Smithfield - LH

Lot 149 - Duncan's Creek

626 Duncan Creek Road
Lillington, NC 27546

Redlines Completed 26-Feb-24 (DP)

FIRST FLOOR PLAN 'ENGLISH COUNTRY'
 SCALE: 1/8"=1'-0" ON 11x17, 1/4"=1'-0" ON 22x34

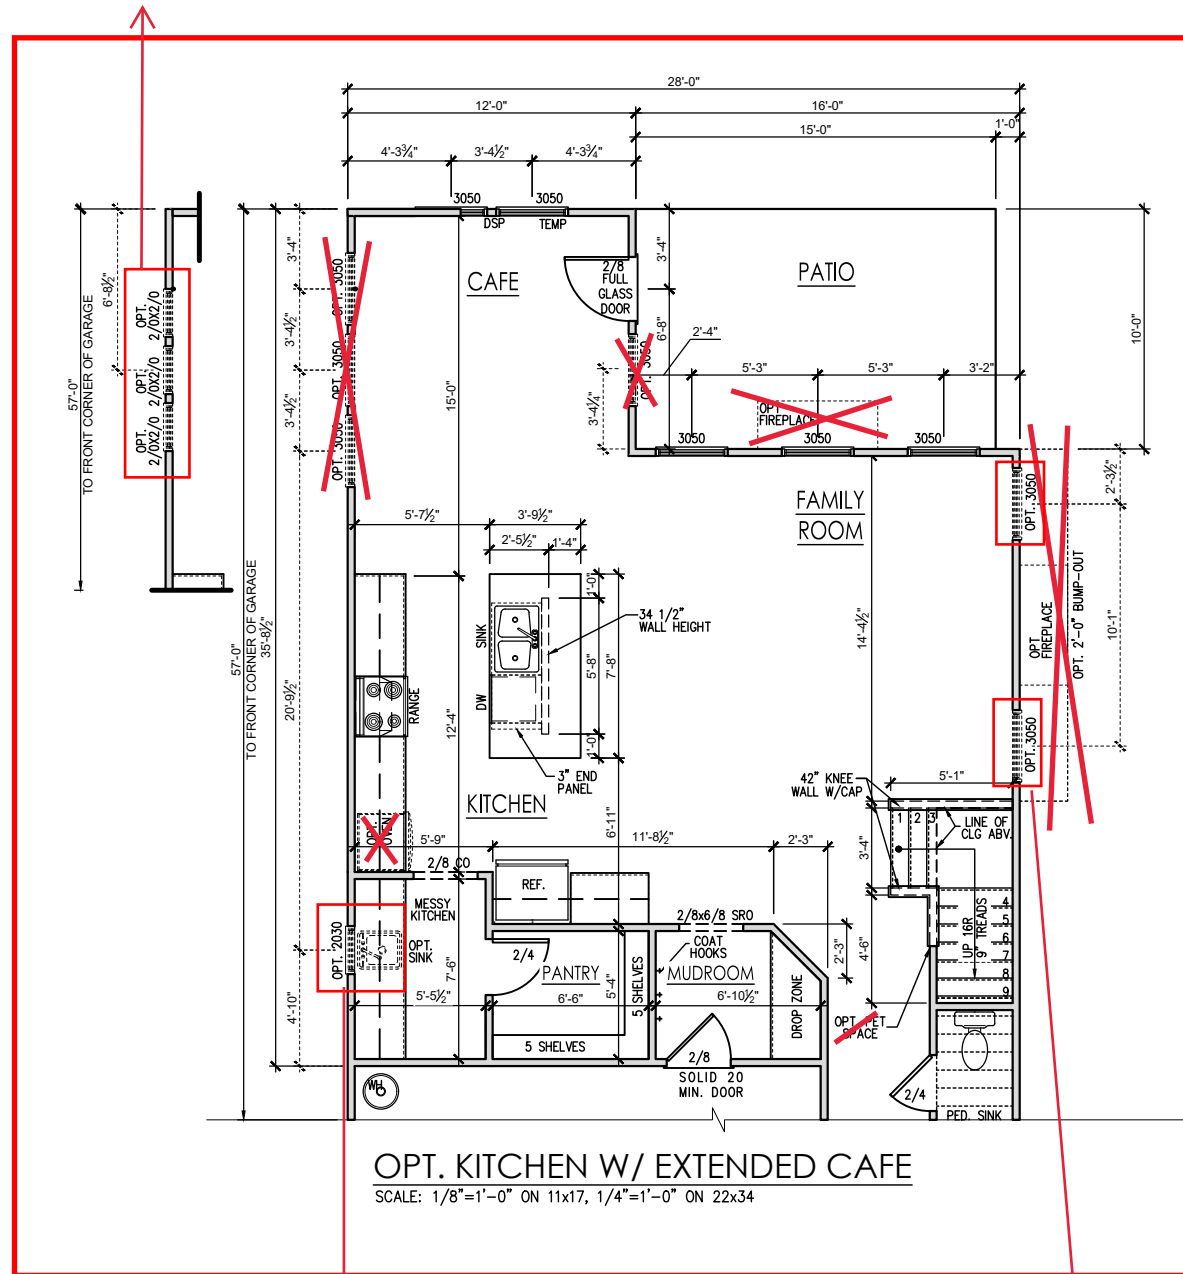
Adding 20 3/0x5/0 Windows in Family

Adding 2/0x30 Window at Powder

Adding Smart Door Delivery

Second Floor Plan Options 'English Country'

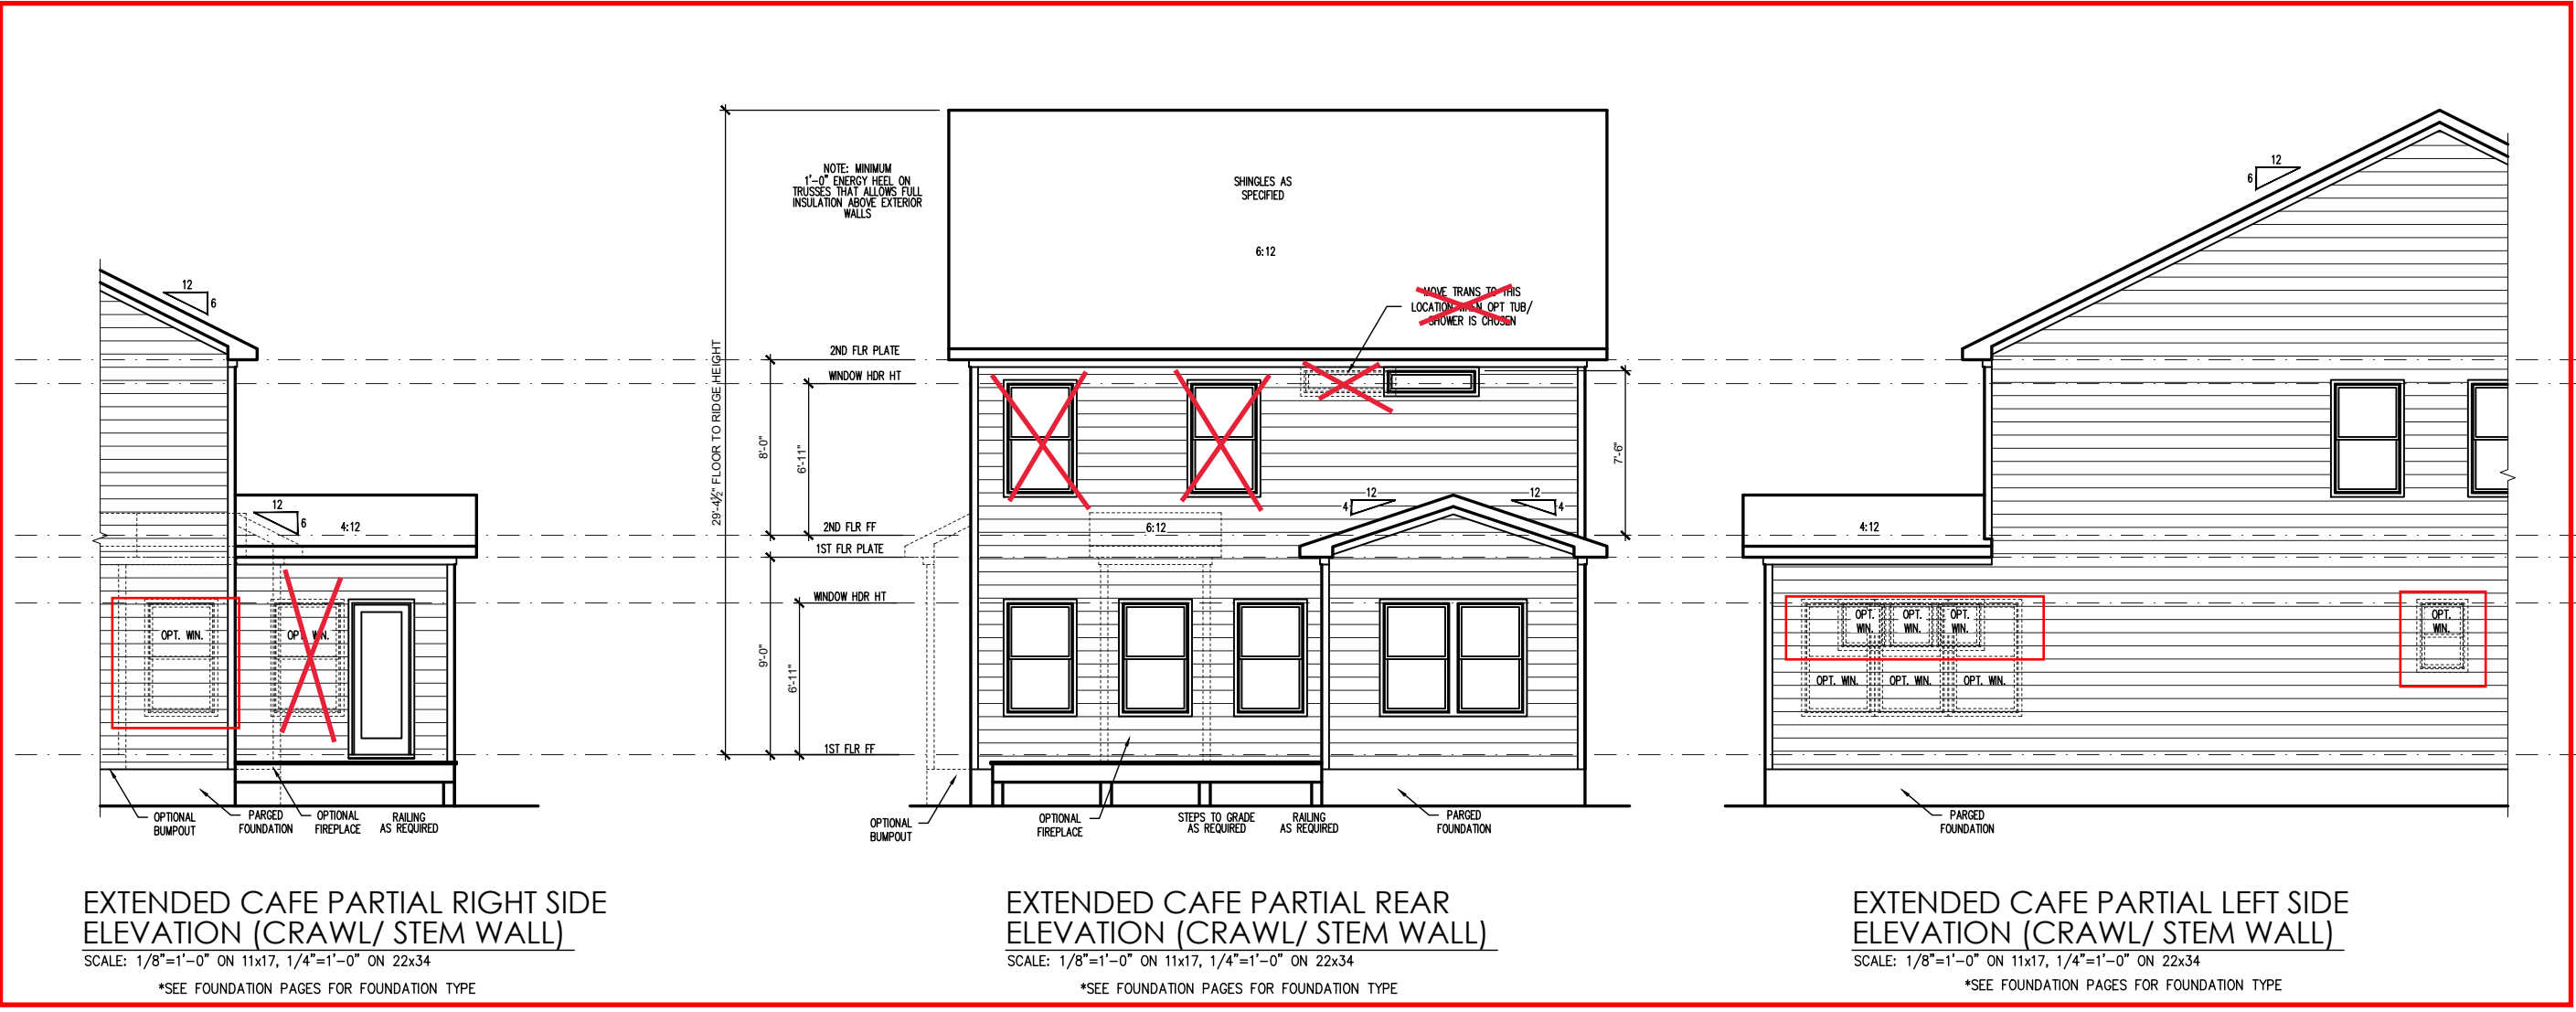
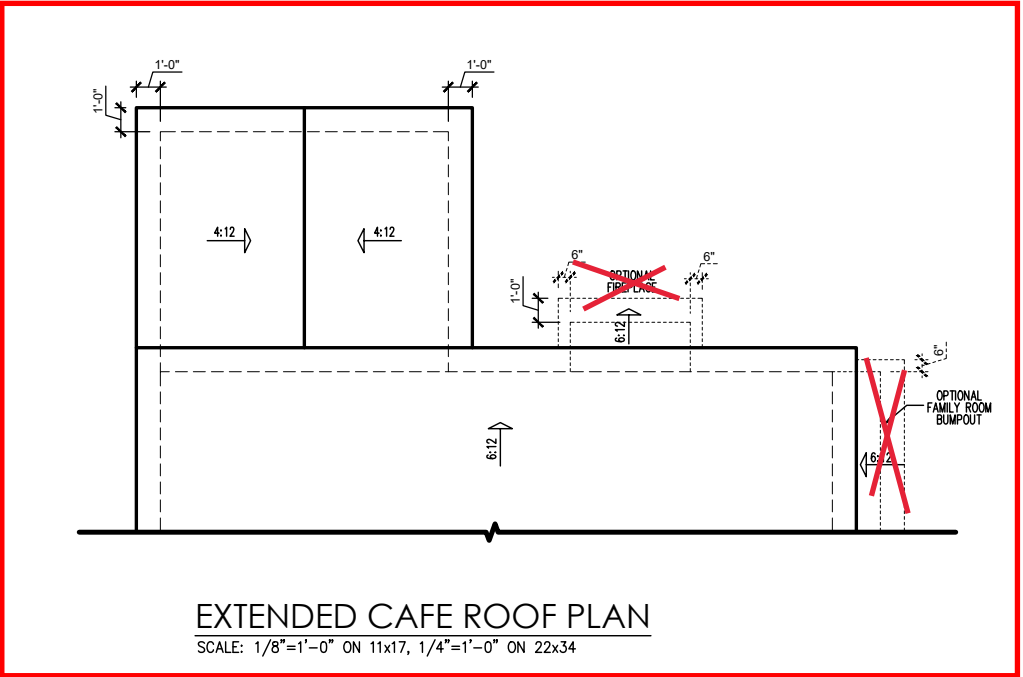
Adding 3) 2/0x2/0 Windows at Extended Cafe

Adding 2/0x3/0 Window at Messy Kitchen and Sink

Adding 2) 3/0x5/0 Windows at Family Room

THE SMITHFIELD - LH
First Floor Electrical 'English Country'

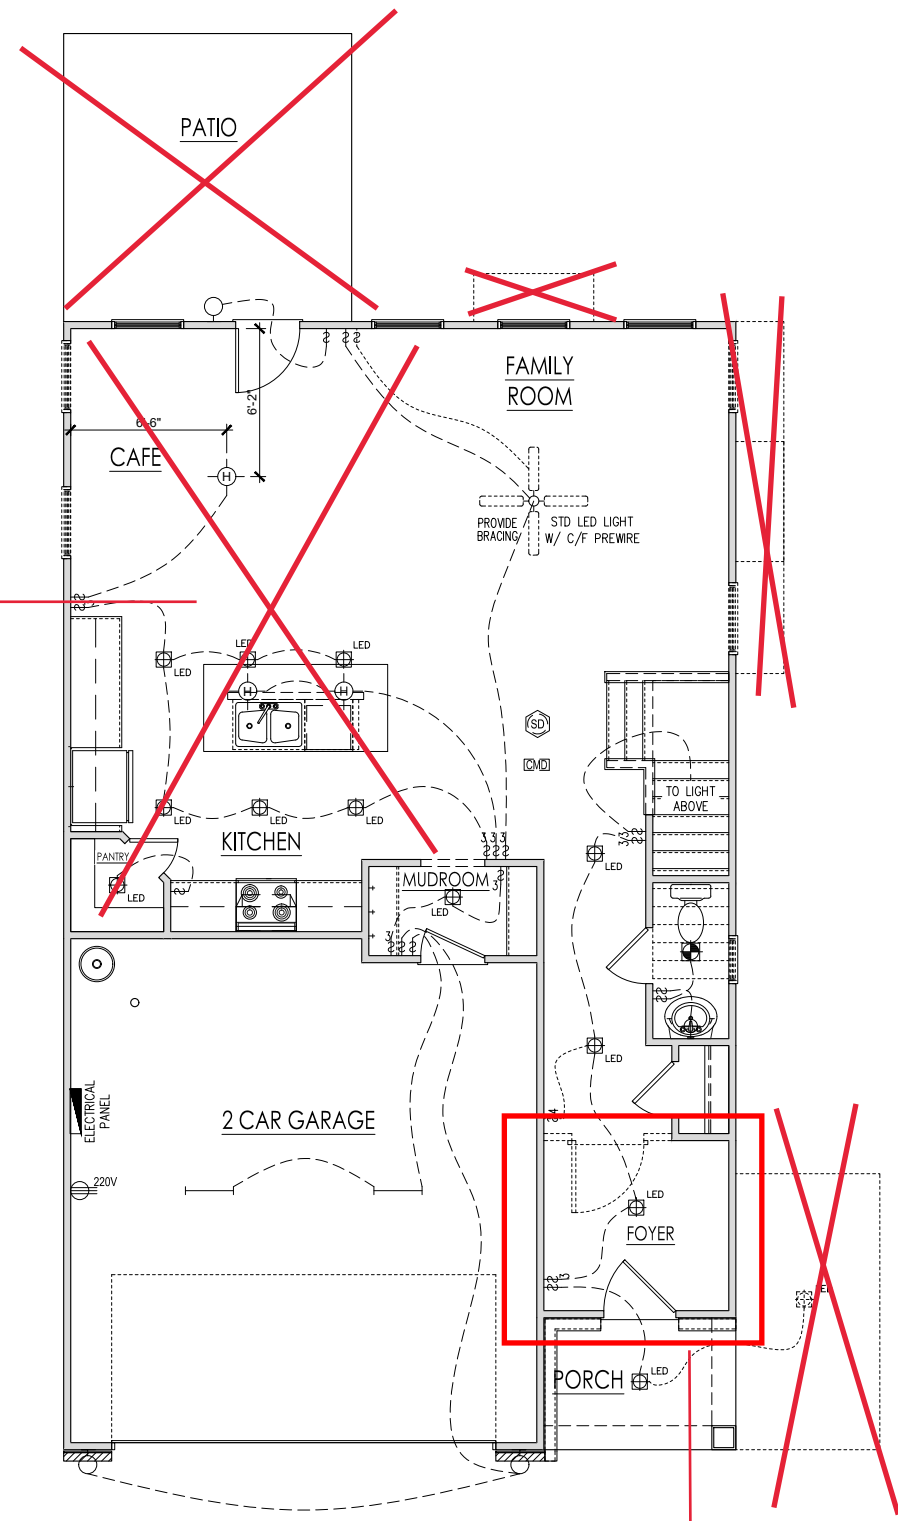
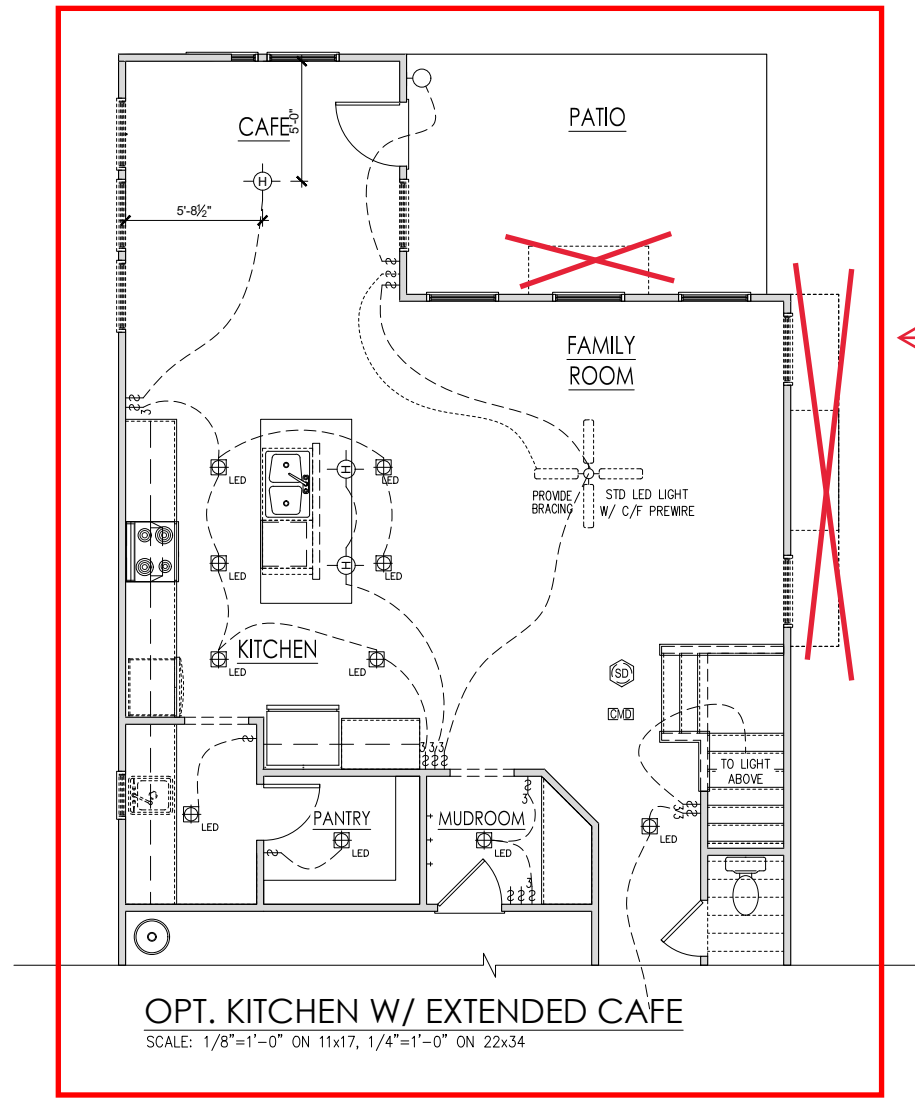
Smart Door Delivery
